BIDDERS BULLETIN

PROJECT: New Auto Service & Car Wash Building
Modern Muffler Tire Pro
1402 South Jeffers
North Platte Nebraska

BB-1

DATE ISSUED: April 23, 2012

For: _____

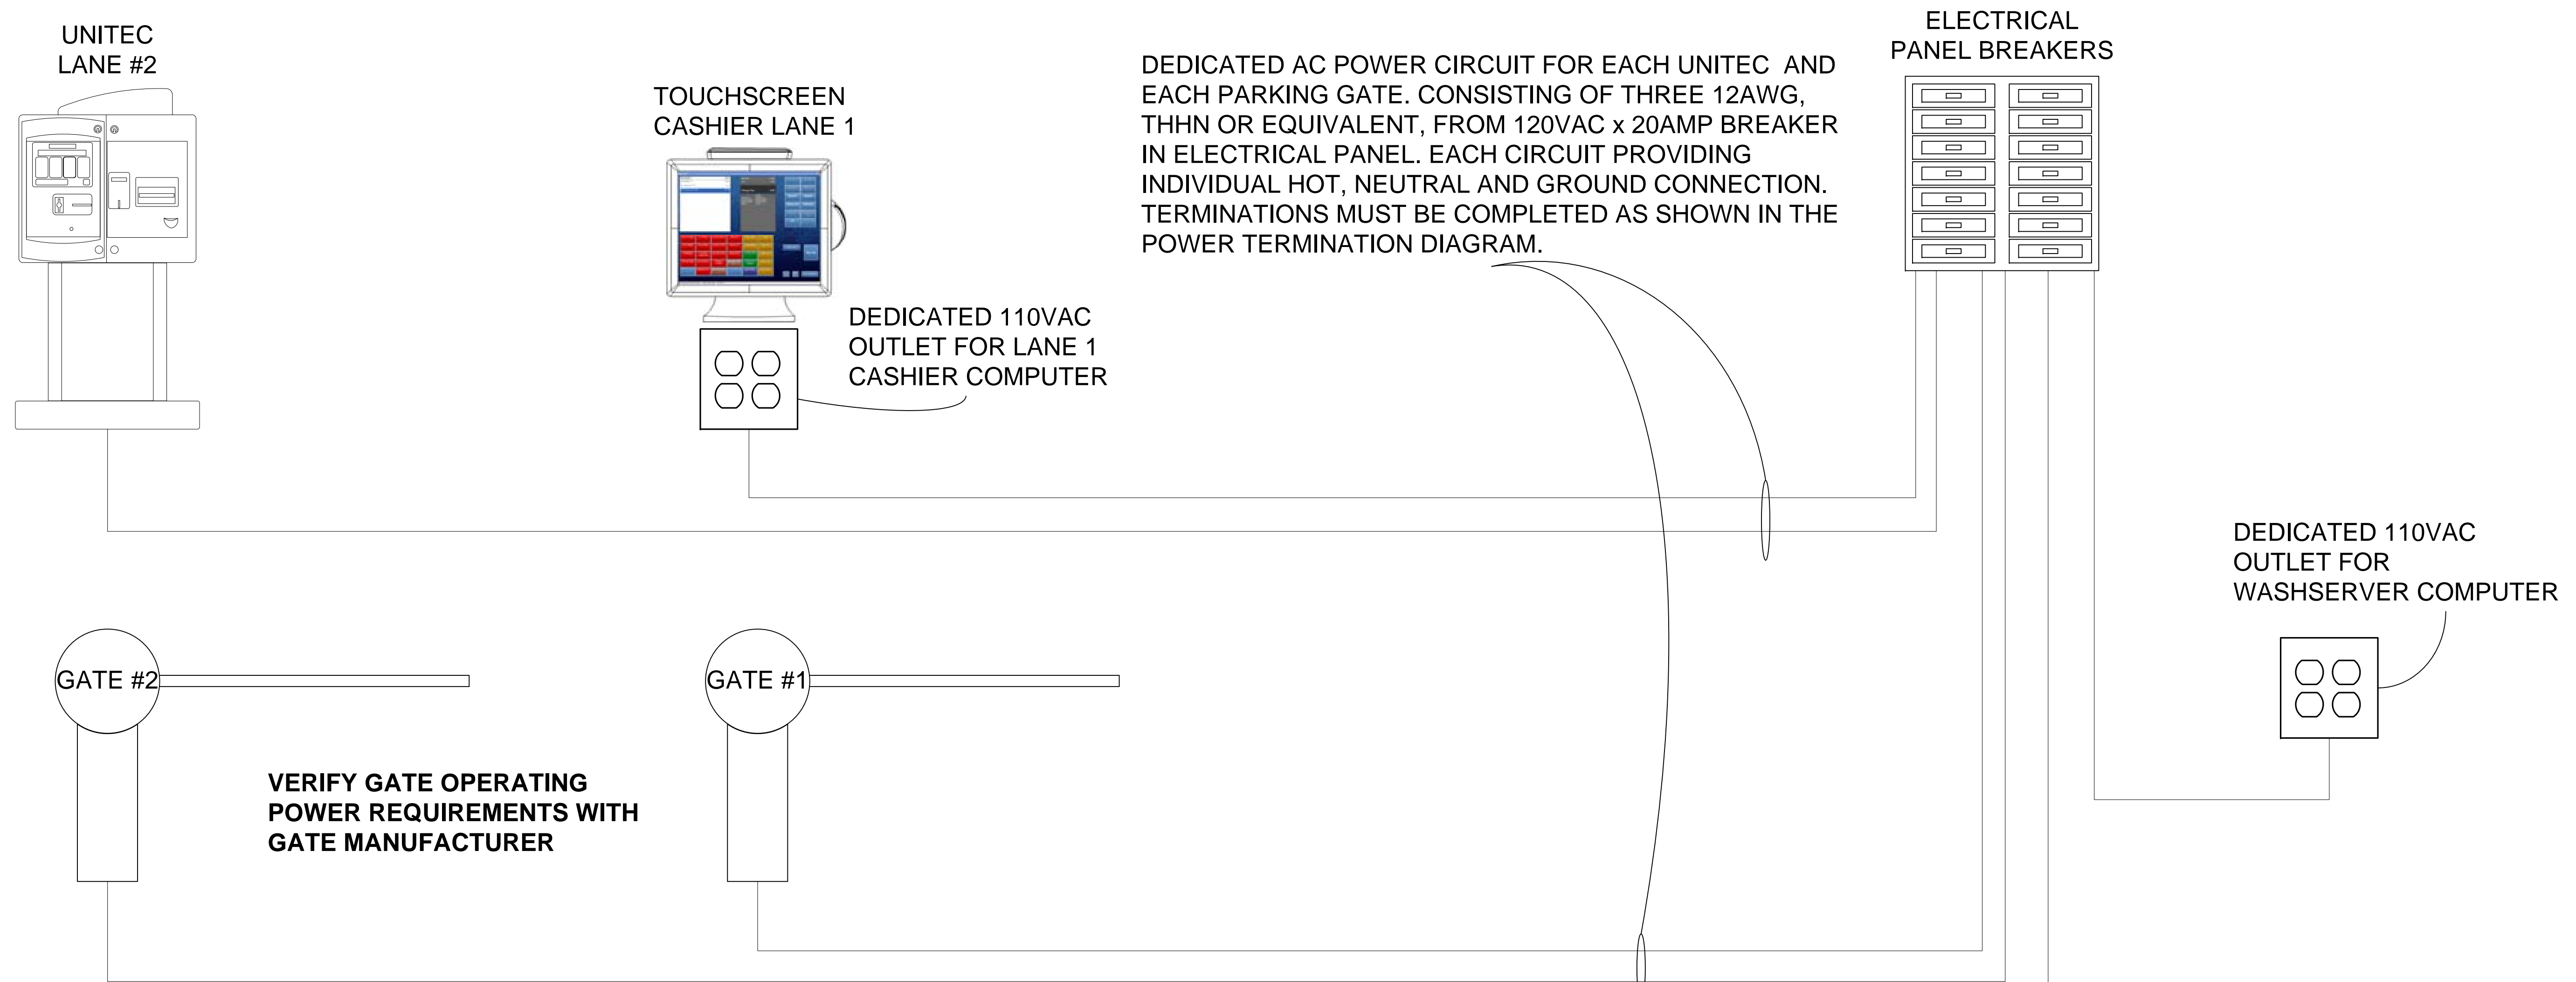
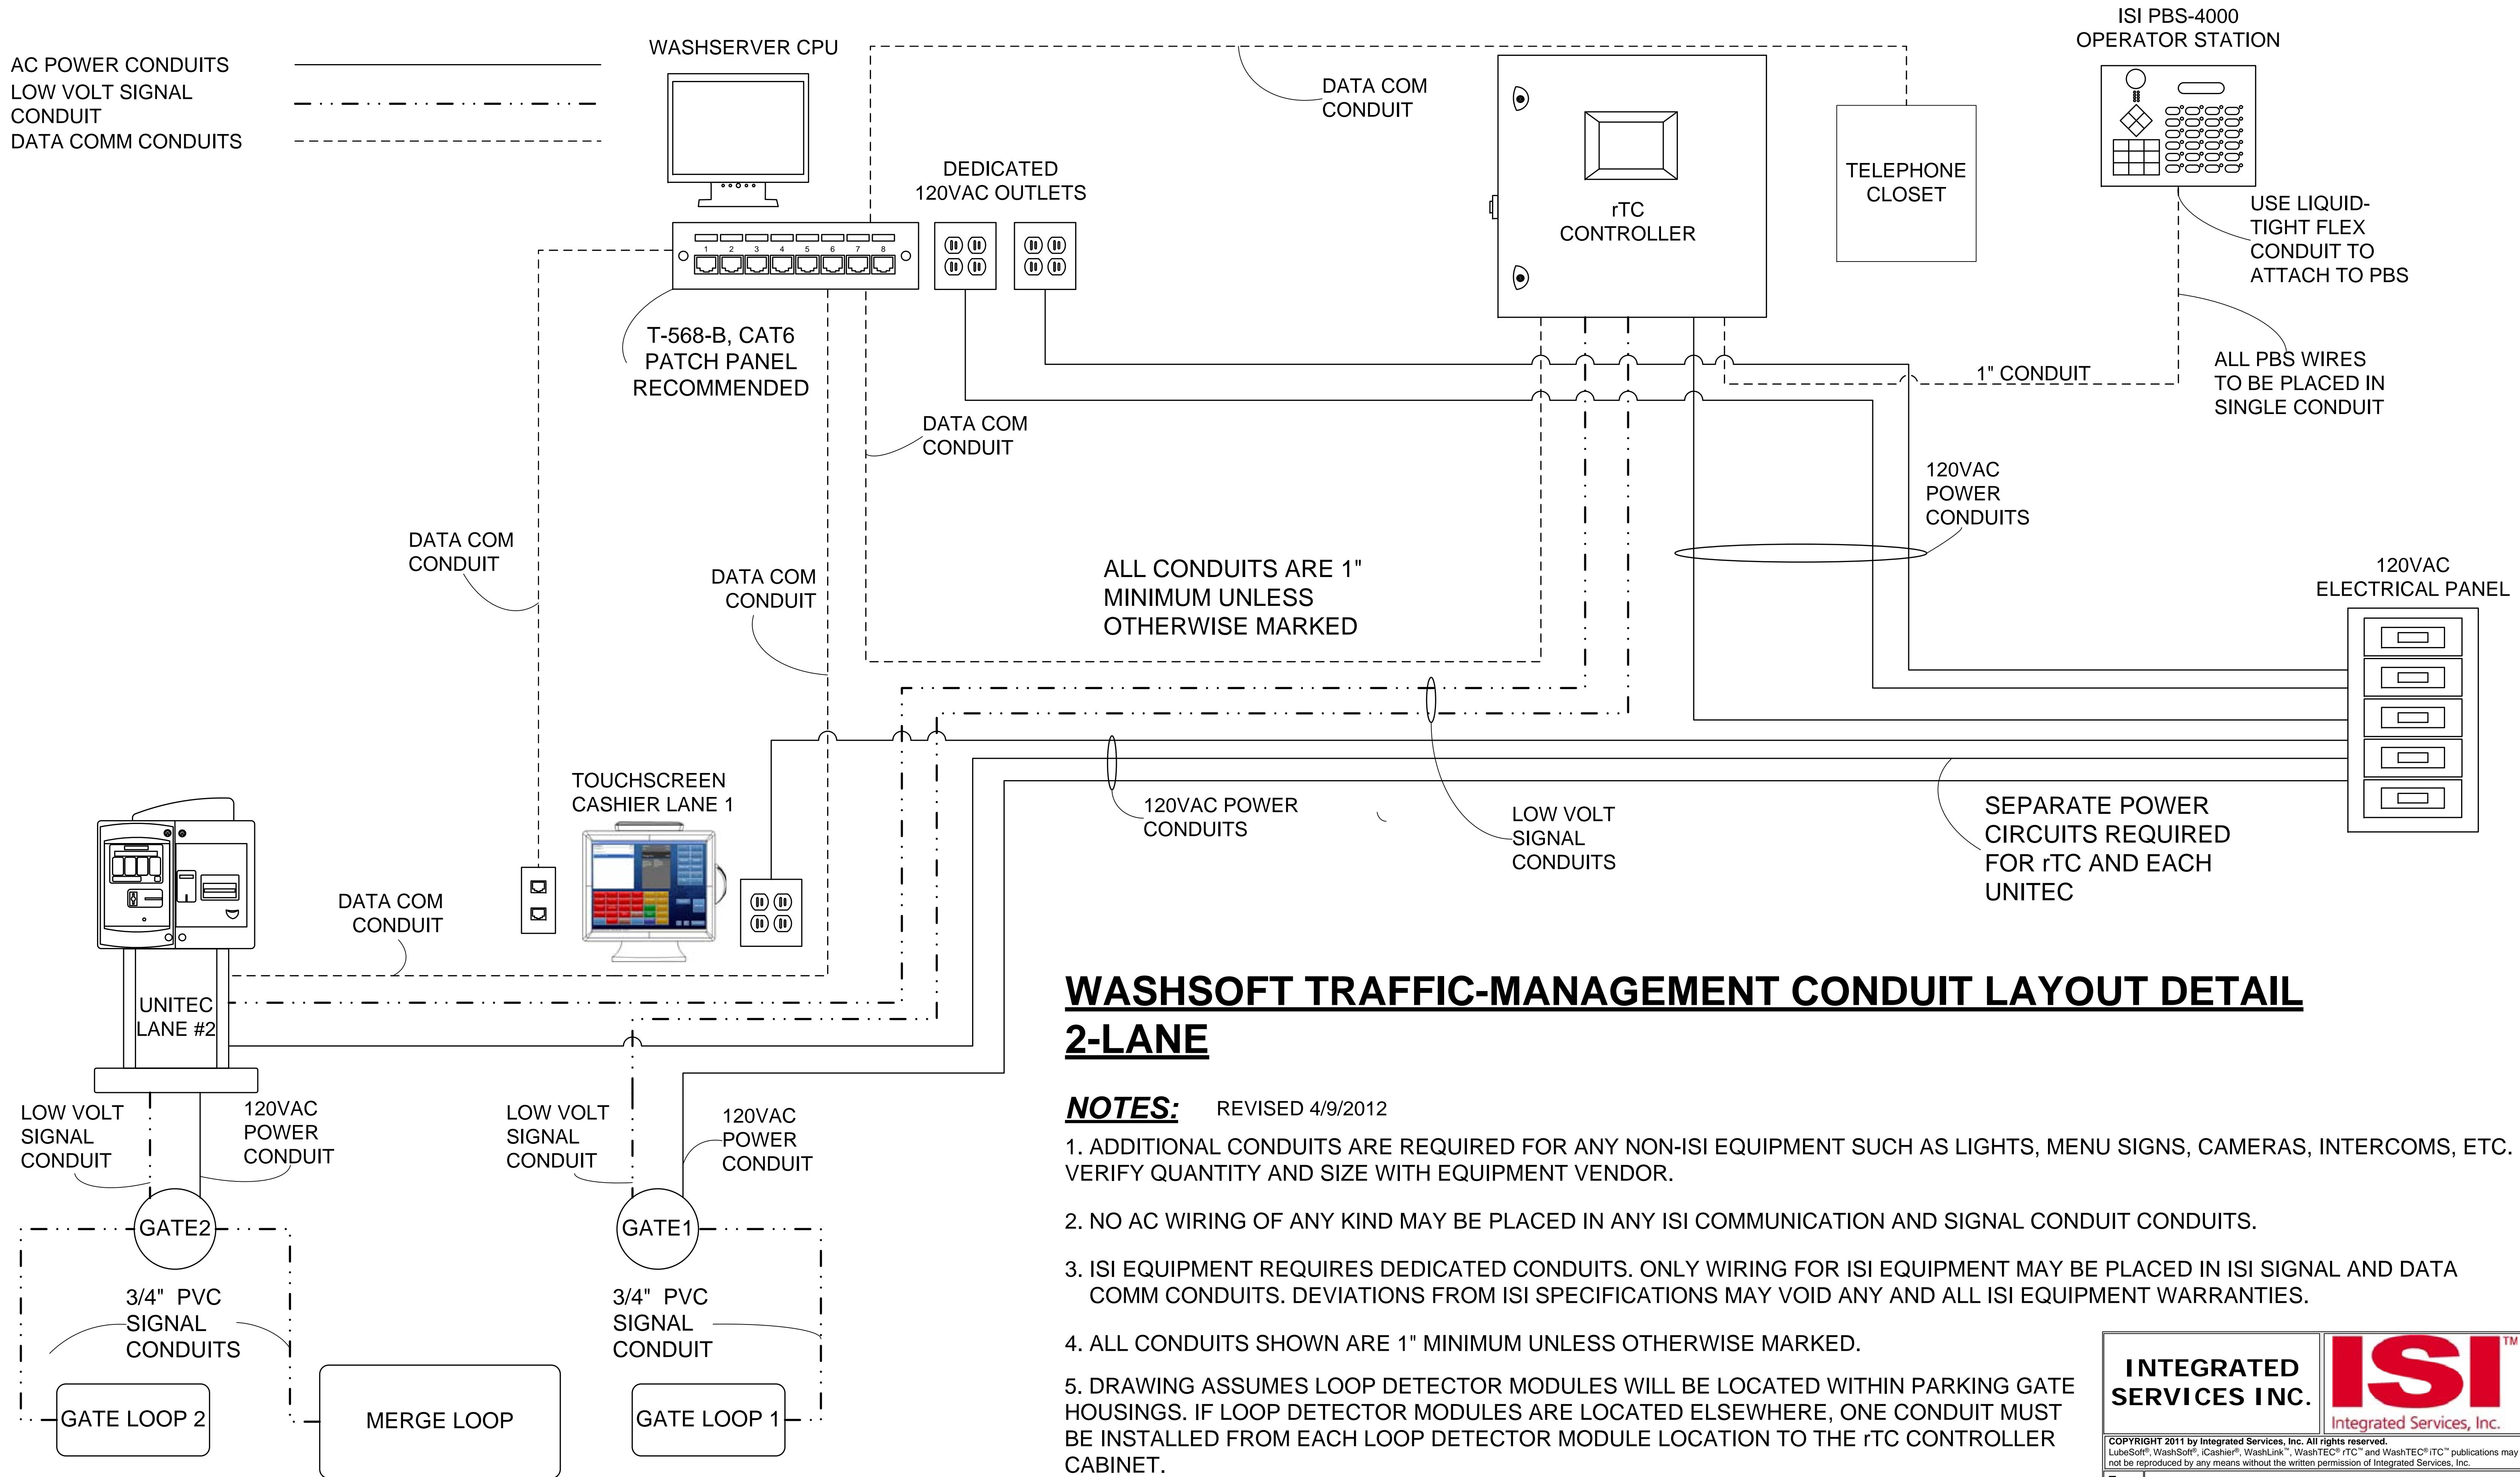
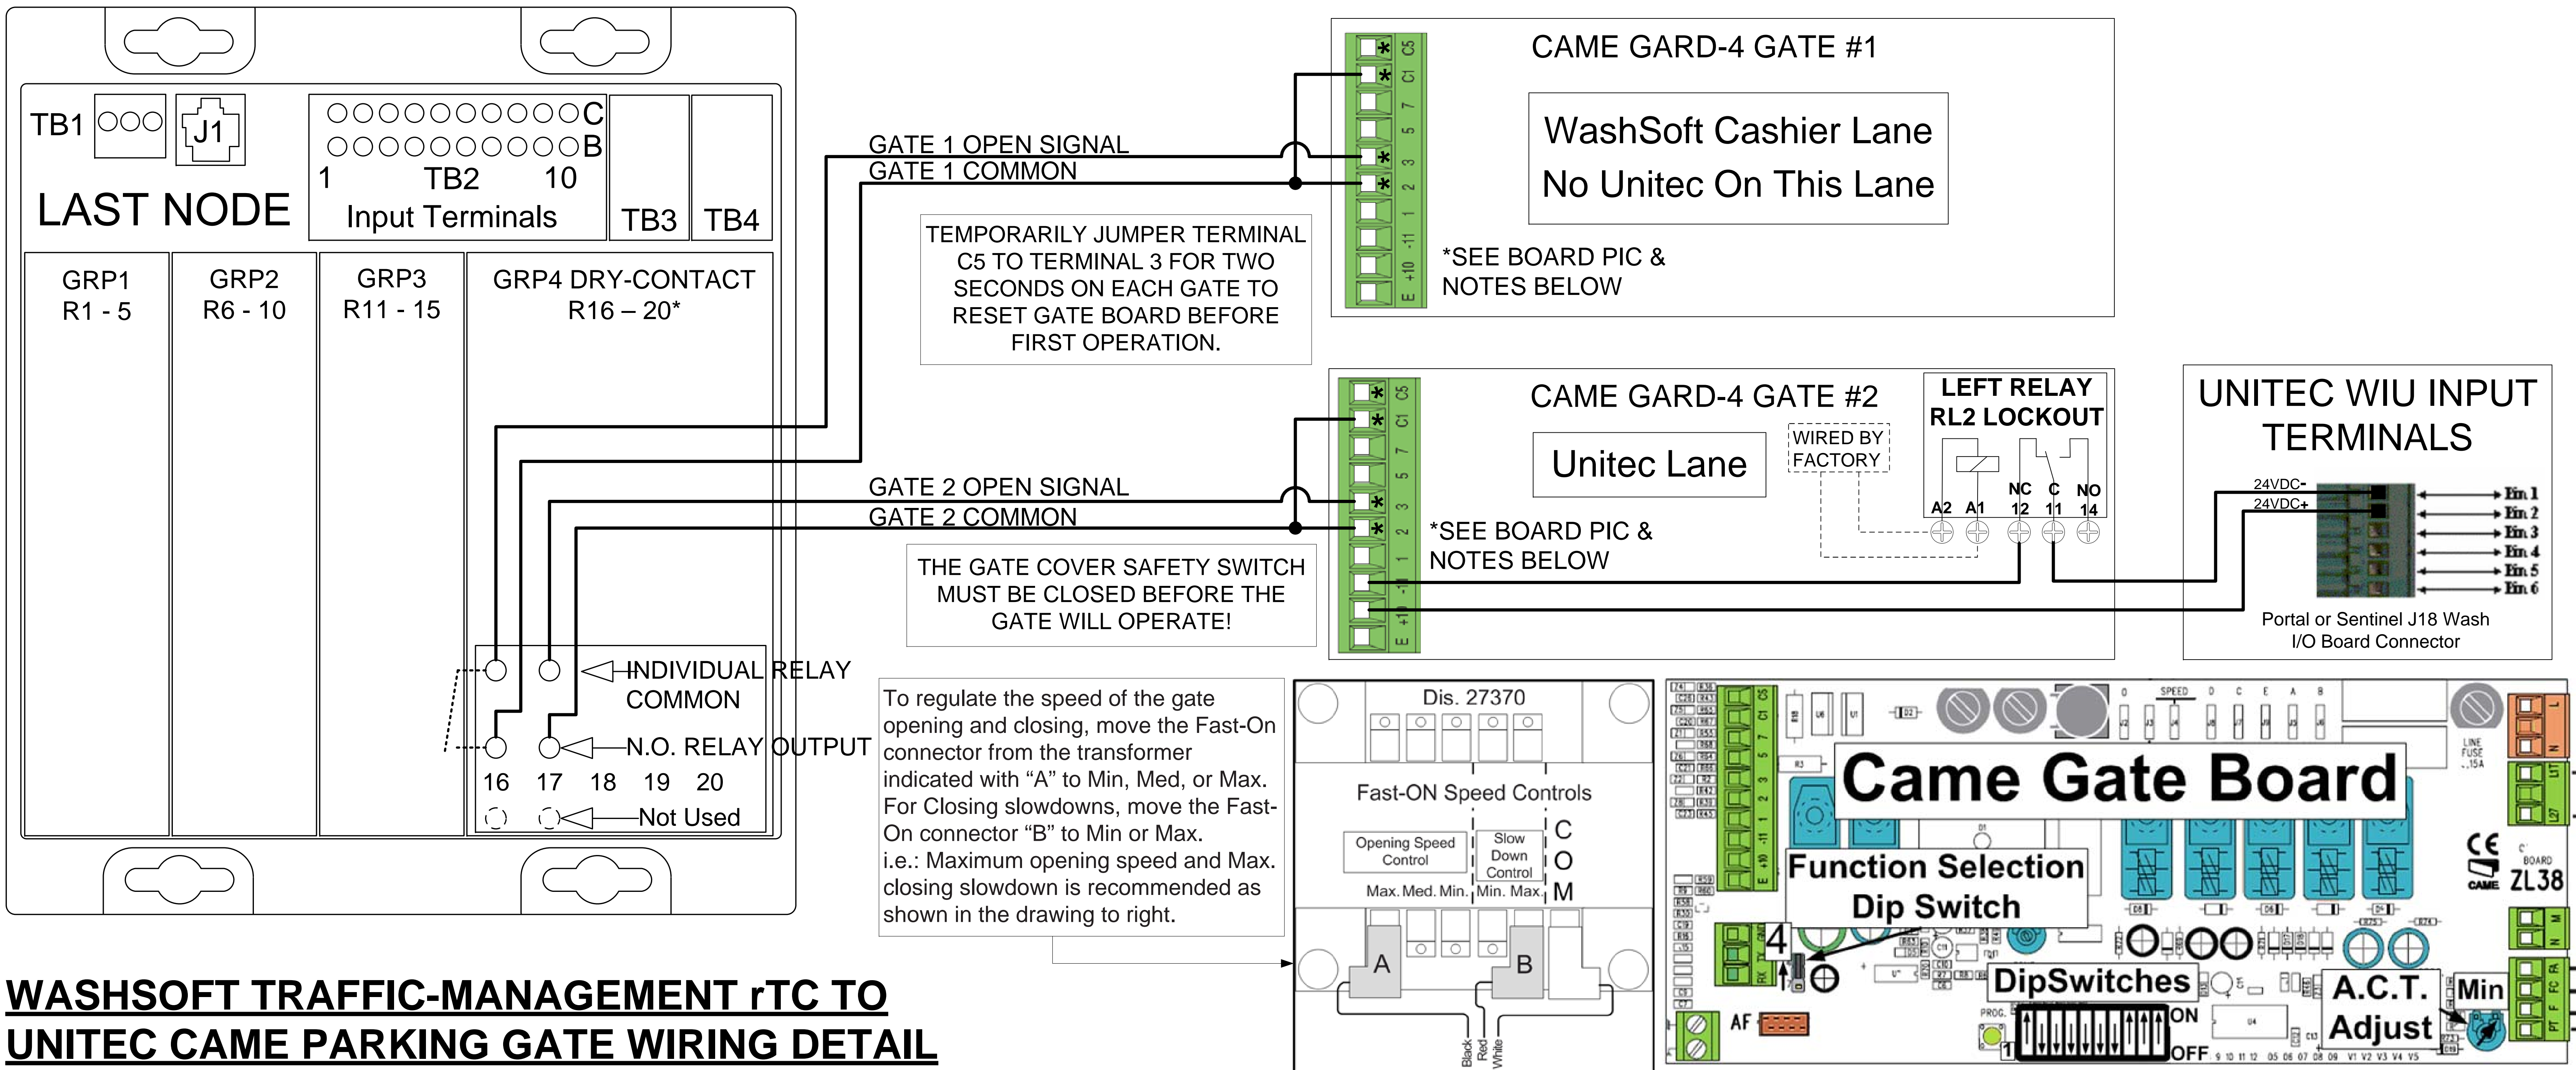
Item #13: E201 – Traffic Management System: Provide conduits and control wiring for traffic management system furnished by Integrated Services Inc. (ISI) as called out on Traffic Management drawings included in this addendum. Coordinate exact requirements with owner and supplier.
